**ADDENDUM NO. 1**

Date: August 29, 2018  
Project: **Secondary Treatment Plant Upgrade & Recycled Water Expansion**  
Job No.: 12600-07/16650-02

#### **Sheet AS-8**

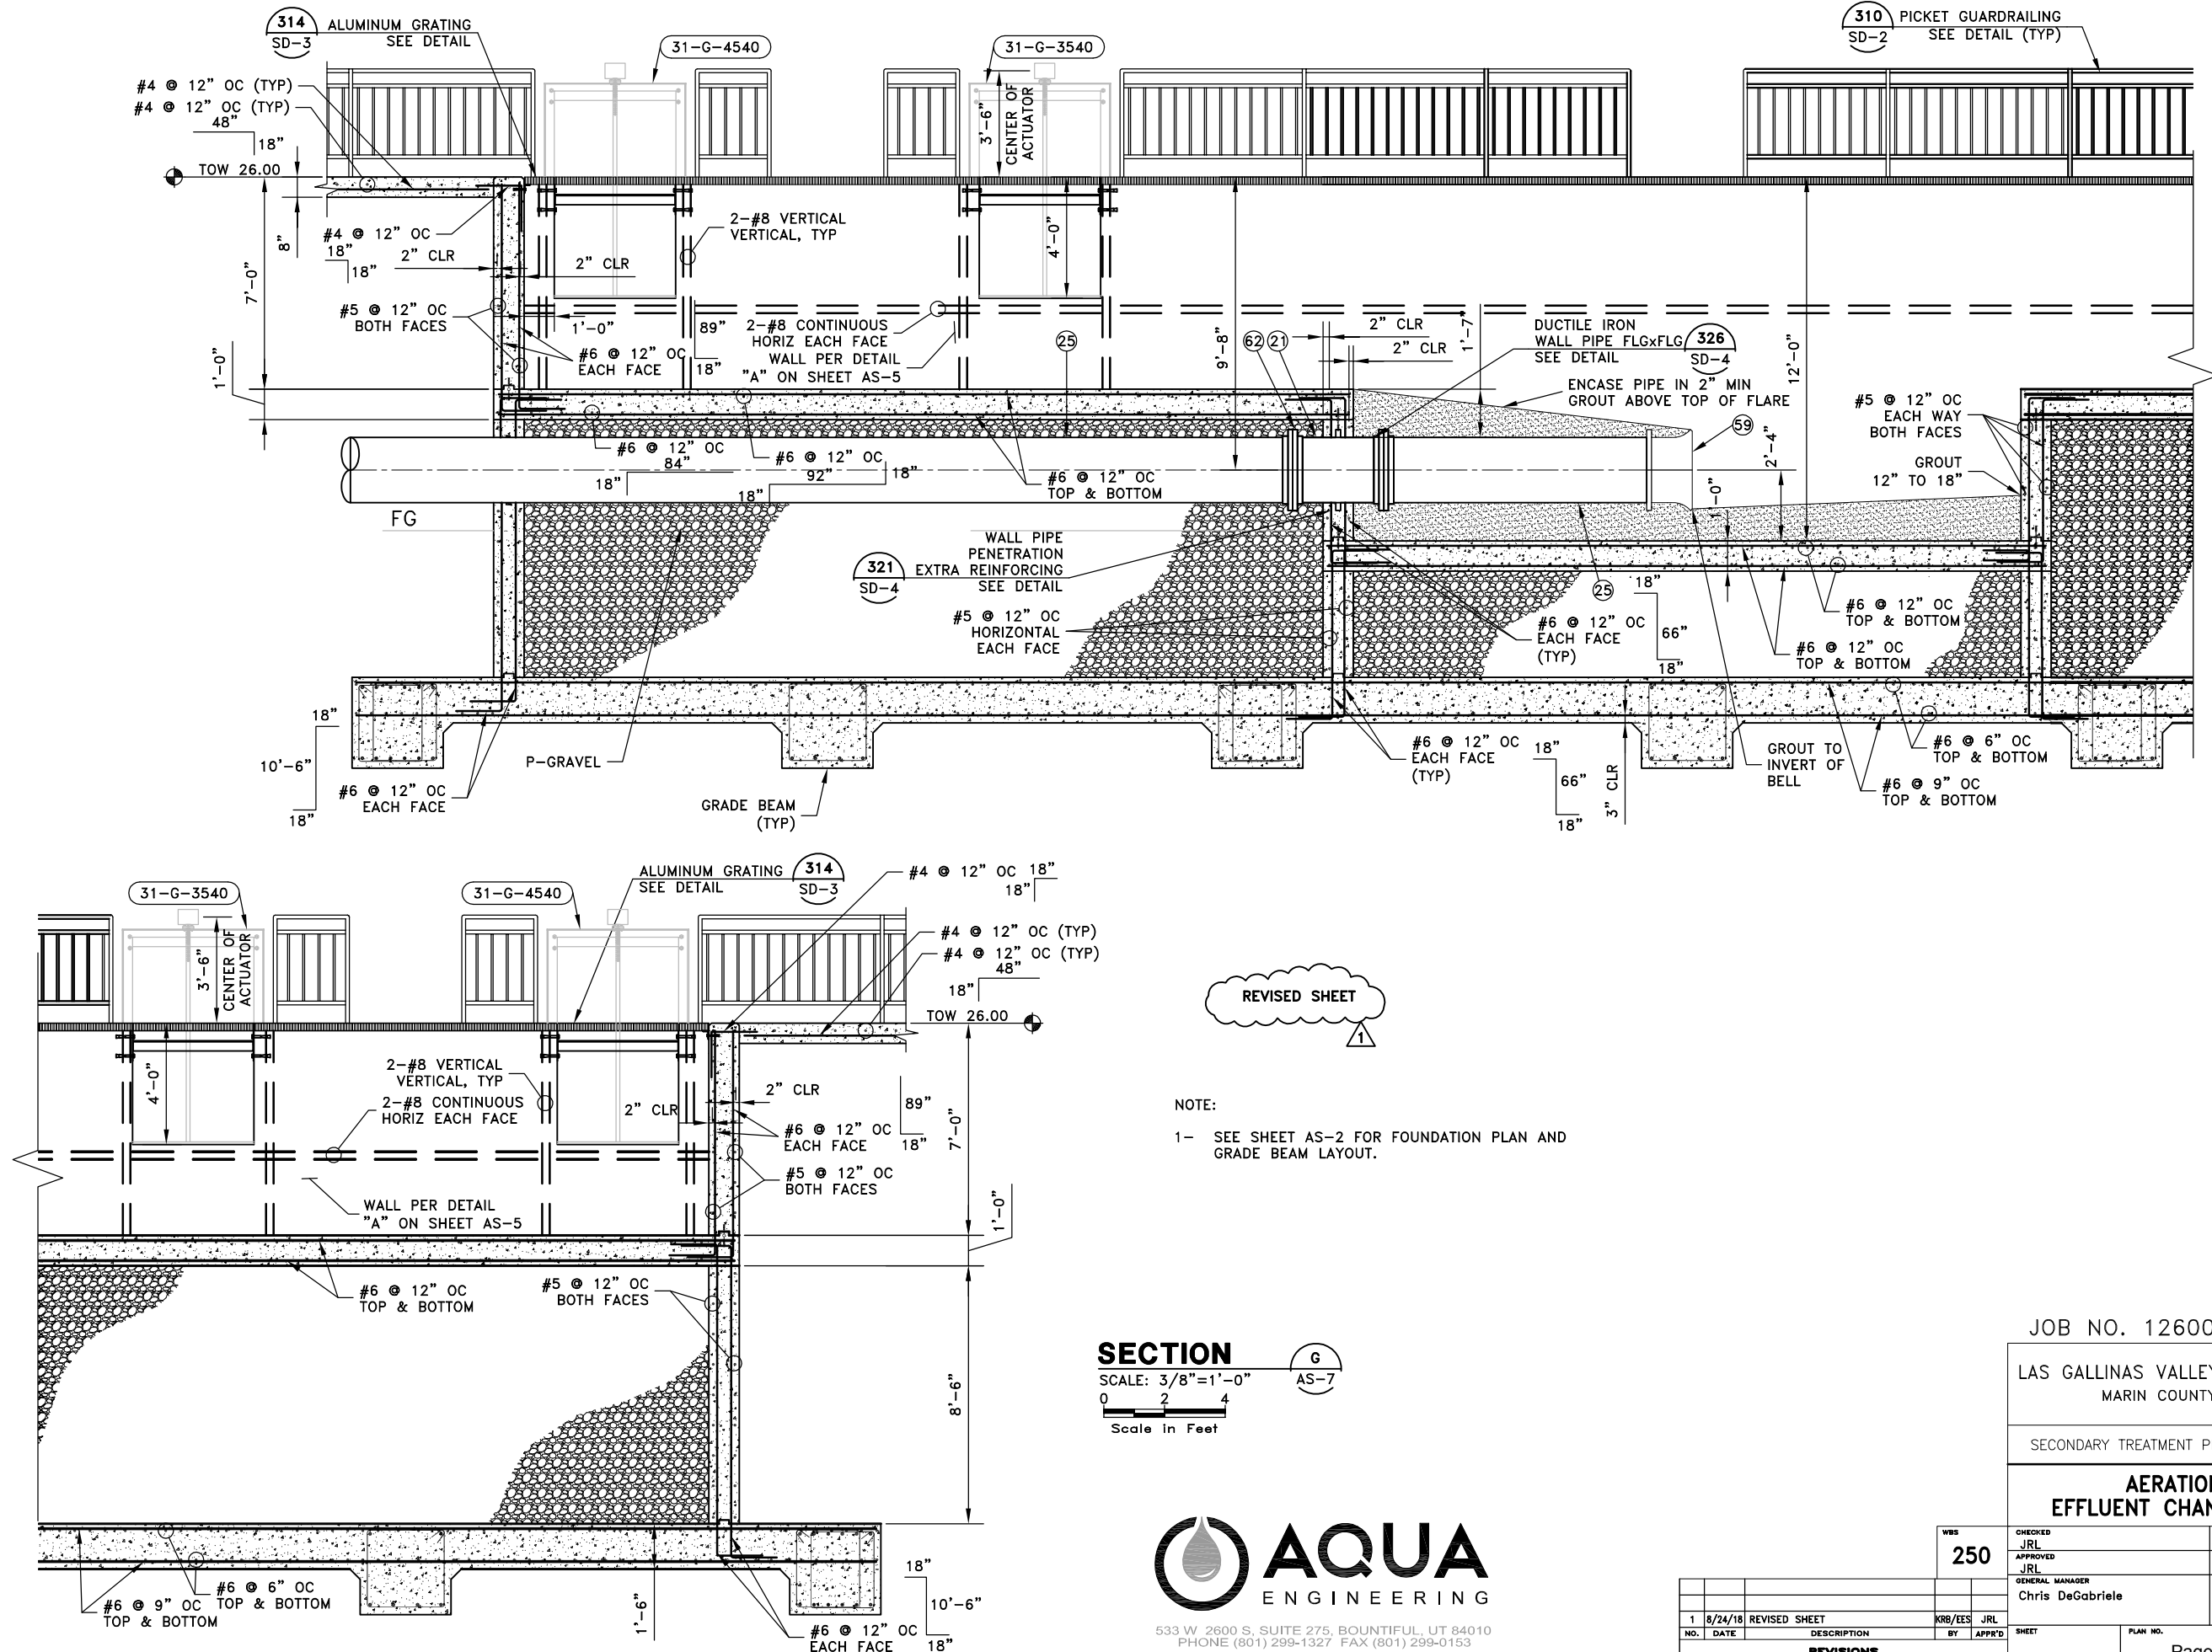
15. **Sheet AS-8:** This sheet (namely Section ‘G’) has been revised to correctly show the relationship of the grade beams and floor slabs relative to the channel structure. This section now matches the design intent and the dimensions/configuration shown in the related sections J & K on sheet AS-9. **A revised version of sheet AS-8 is provided as an attachment to this addendum.**
